PROBLEM *Solver*[™] BULLETIN

Front End Steering Shimmy

2005-2008 Ford
F250 Super Duty

MOOG® SSD131 Super Trail Boss Steering Stabilizer

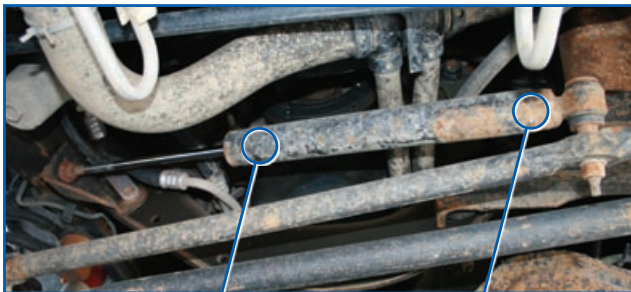
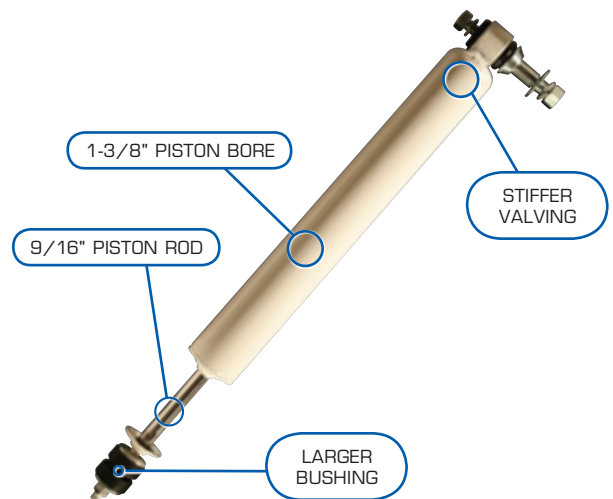
Severe front end vibration/shimmy at moderate highway speeds

There are reported problems with severe vibration/shimmy in late-model Ford F250 Super Duty pickup trucks. This is due to failure of the OE steering stabilizer.

The OE design is prone to premature failure and can cause:

- Severe front end shimmy
- Loss of control
- Excessive tire wear

STANDARD PISTON BORE SIZE OF 1"

STANDARD VALVING

The SSD131 offers a larger bore diameter and tighter valving to eliminate steering oscillation and provide the driver greater vehicle control. Its premium design works well with larger diameter tires and will last longer under severe driving conditions.

- Chromed hardened 9/16" piston rod with 1-3/8" bore
- Stiffer valving provides better dampening
- Larger bushings for longer life
- White powder coat finish
- Enhanced design improves tire and ball joint wear
- Improves control and handling for oversize tires
